Subject: **Topical Report NEDO-33288 – APPLICATION OF NUCLEAR
MEASUREMENT ANALYSIS AND CONTROL (NUMAC) FOR
THE ESBWR REACTOR TRIP SYSTEM**

1. MFN 07-160, RTS Topical Report NEDO-33288 – Markup Index Table and Chapter 7 DCD Tier 1 and Tier 2, Proposed Markups for DCD Revision 4
2. MFN 07-160, RTS Topical Report NEDO-33288 – NUMAC Platform Architecture – NEDO-33288

**Markup Index Table and
Chapter 7 DCD Tier 1 and Tier 2, Proposed Markups for
DCD Revision 4**

Figure 2.2.5-1. Basic Configuration of a Typical SRNM Division (Subsystem)

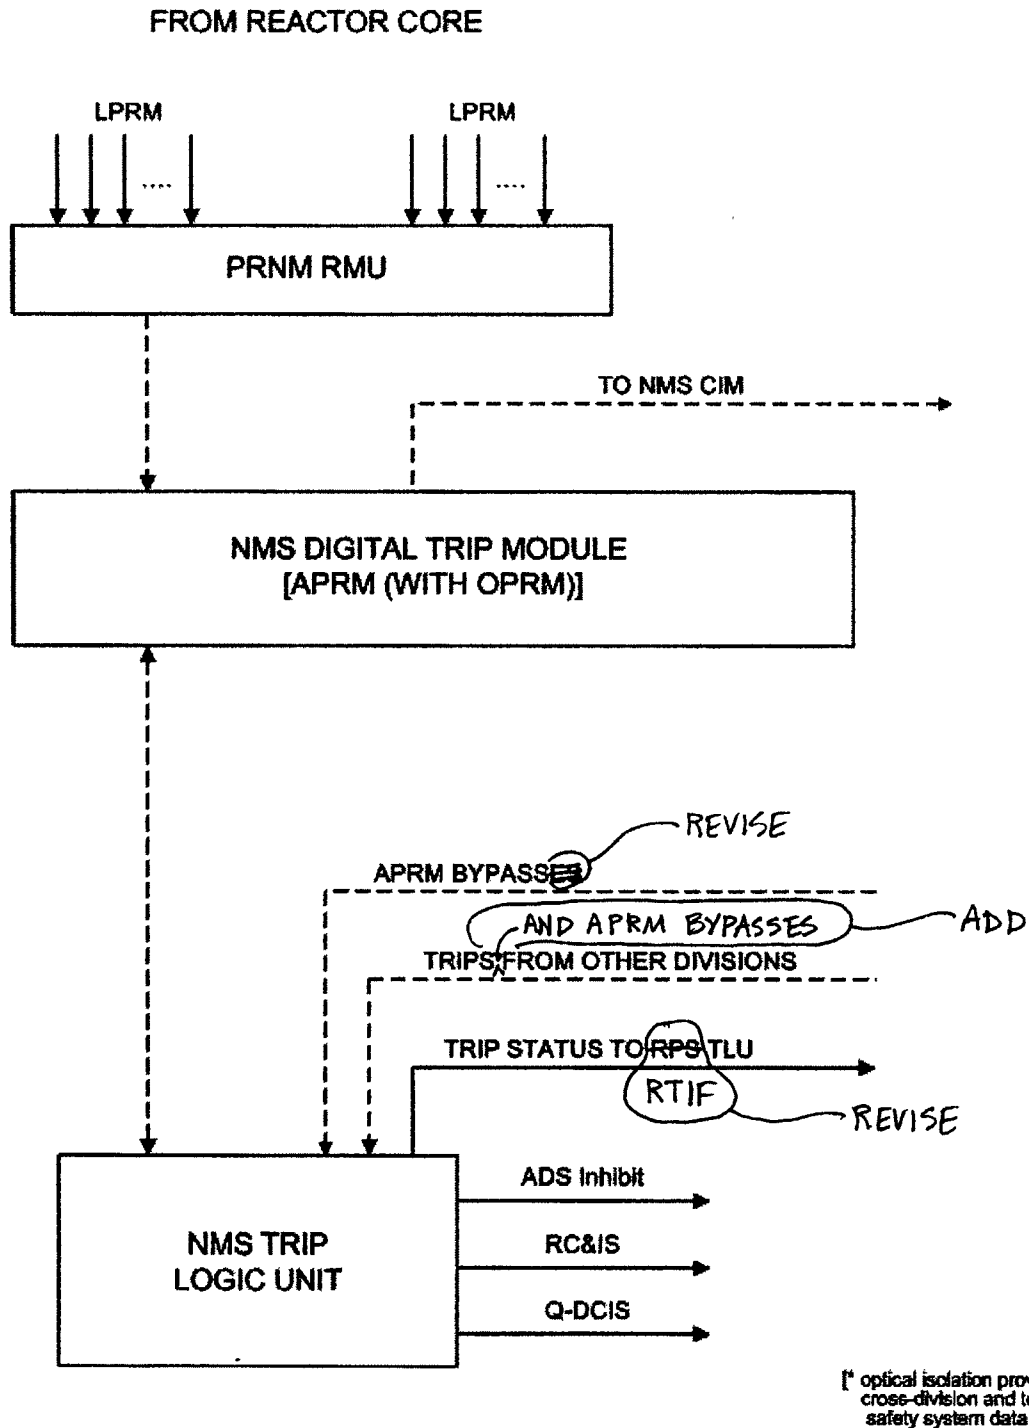
REVISE

[* optical isolation provided for
cross-division and to non-
safety system data path]

Figure 7.2-5. Basic Configuration of a Typical PRNM Subsystem

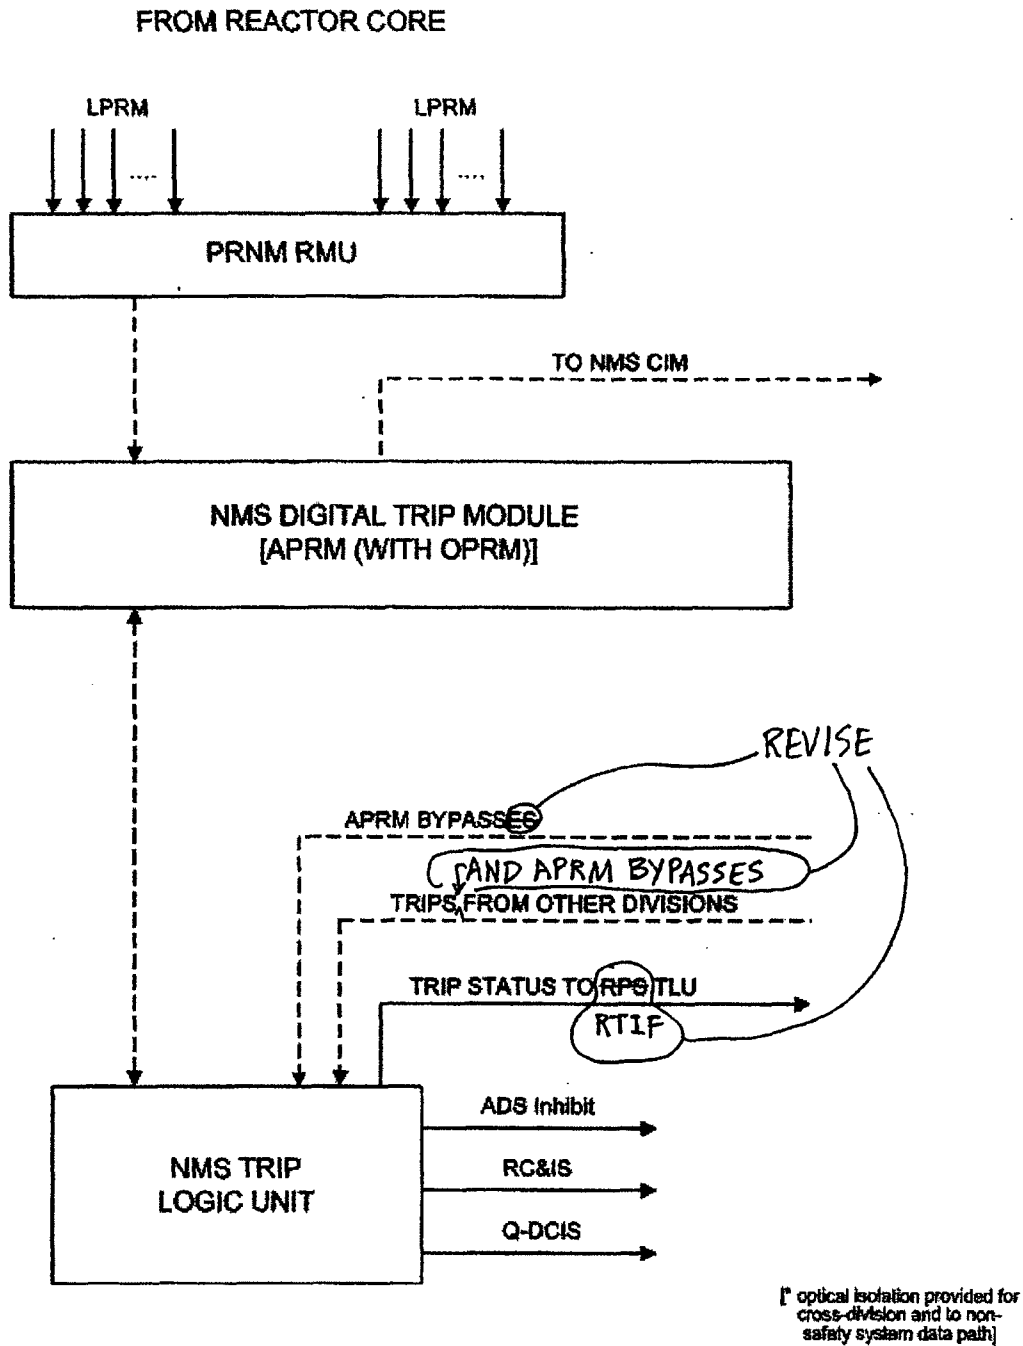
REVISE
